DEVELOPMENT REVIEW BOARD REPORT

SUBJECT **Findlay 80 at 136th Street and Shea Boulevard
21-PP-2003**

REQUEST Request approval of a Preliminary Plat and entry feature for 66 residential lots with amended development standards on an 80+/-acre parcel.

Stipulations for Case: 21-PP-2003

PRELIMINARY PLAT FOR FINDLAY 80 @ 136TH/SHEA

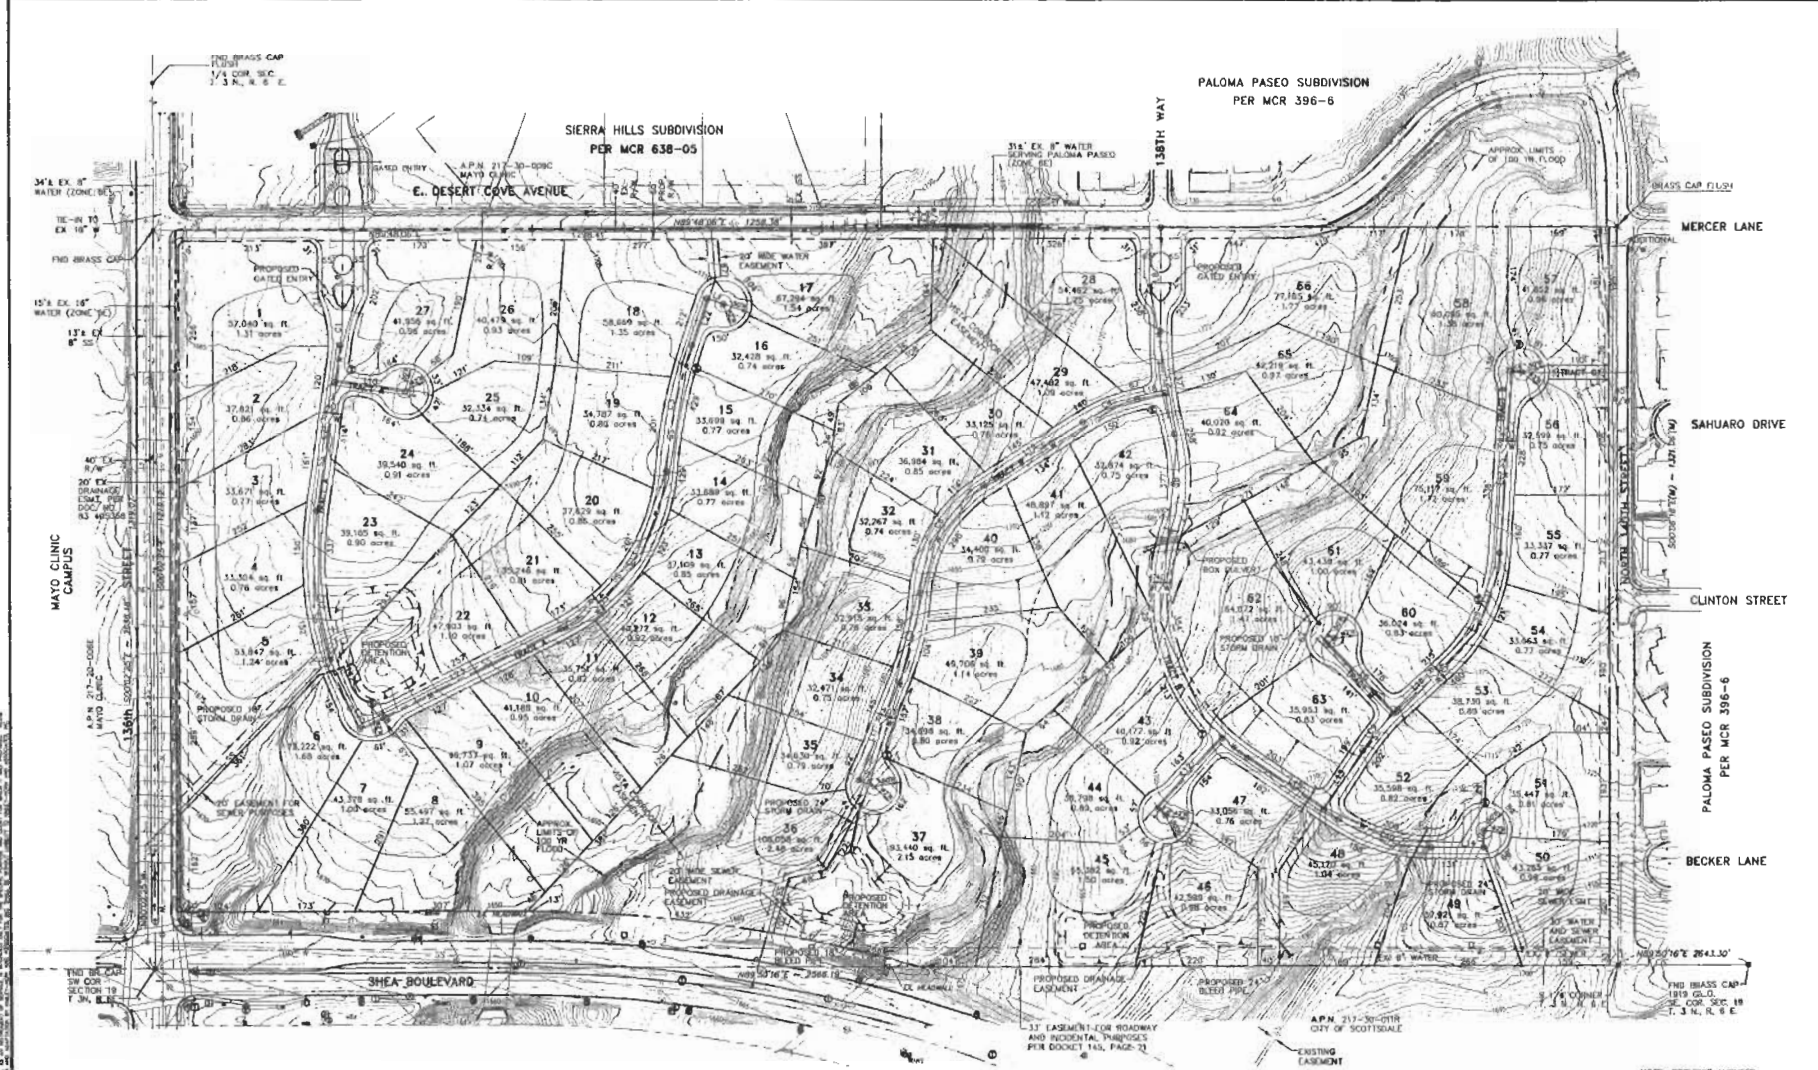
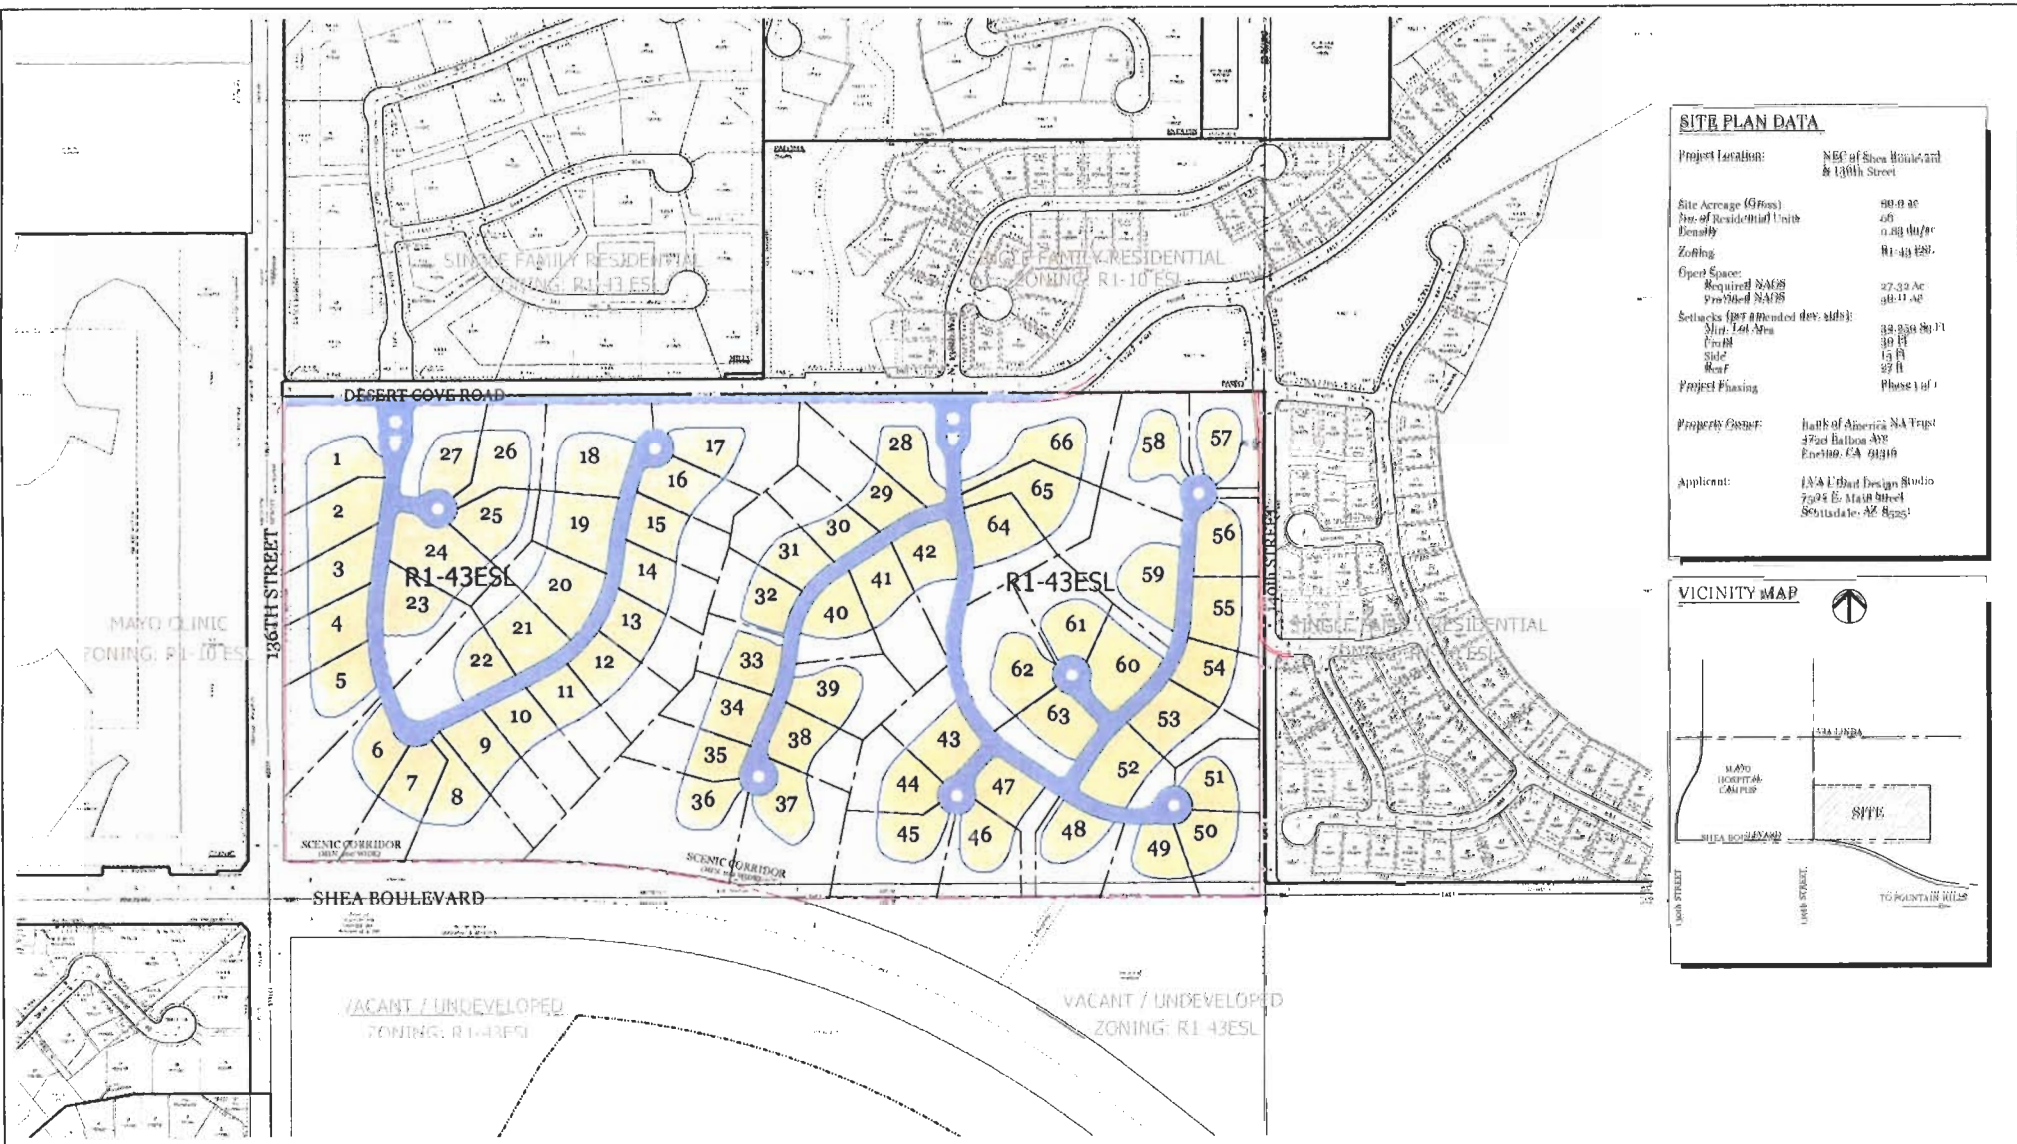
- a. The location and configuration of all site improvements shall be constructed to be consistent with the Preliminary Plat submitted by Kimley-Horn and Associates, Inc., dated 11/18/2004 by City staff.
- b. The Design Standards and Policies Manual (DS&PM).

FINDLAY PROPERTY 136TH STREET & SHEA BOULEVARD SCOTTSDALE, AZ **CONCEPTUAL LANDSCAPE PLAN**

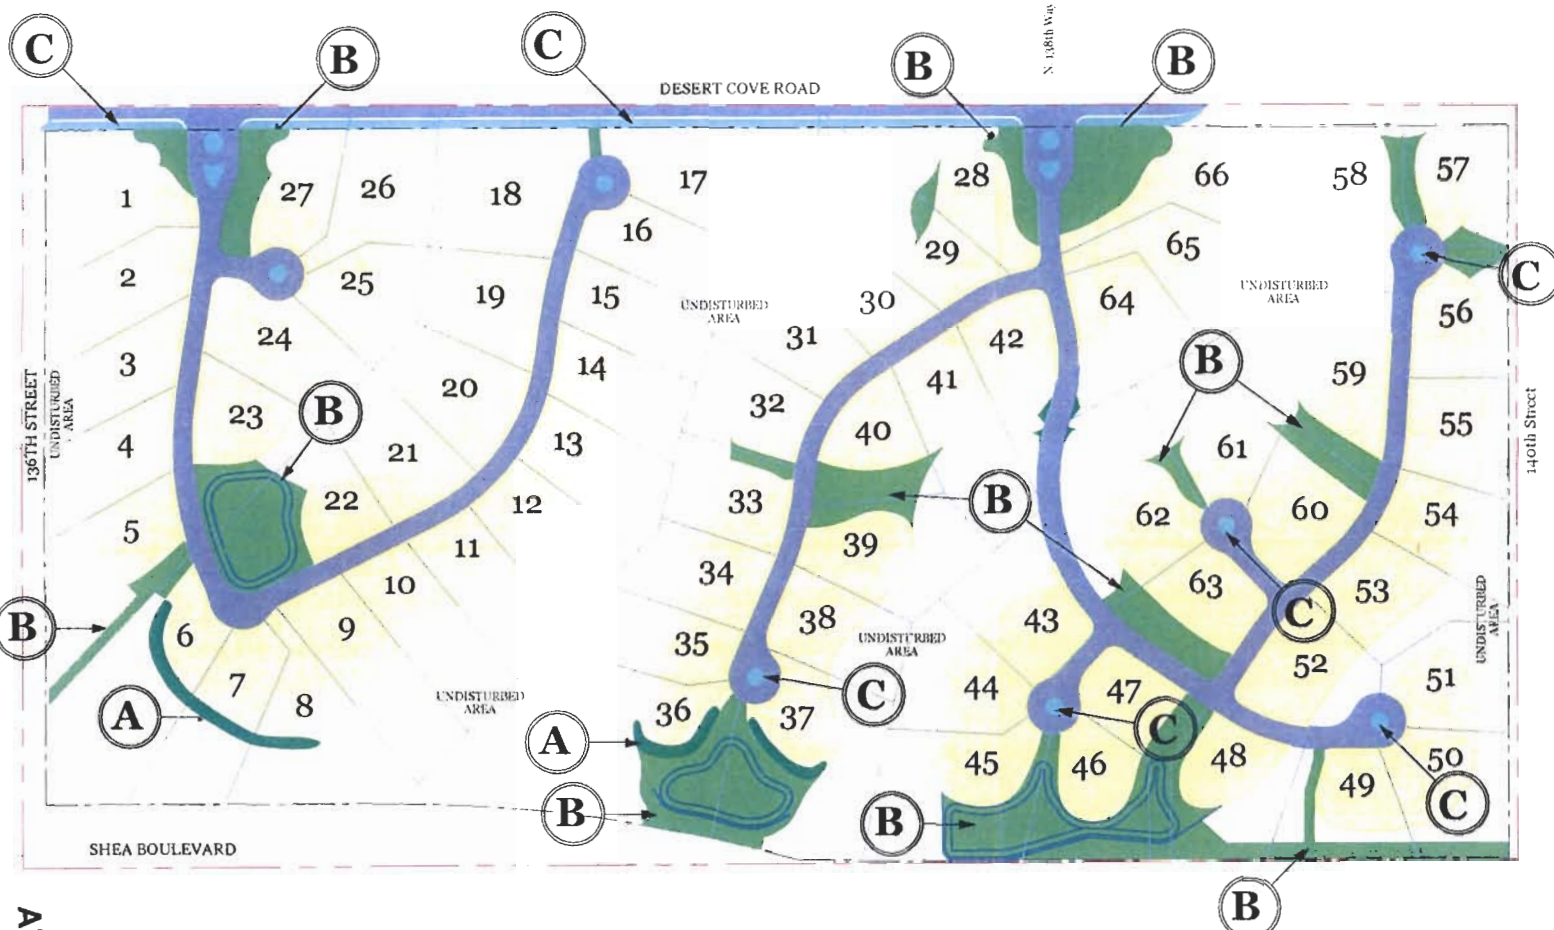
- d. Landscaping, including quantity, size, and location of materials shall be installed to be consistent with the conceptual landscape plan submitted by LVA Urban Design Studio, LLC., dated 5/18/04 by City staff.
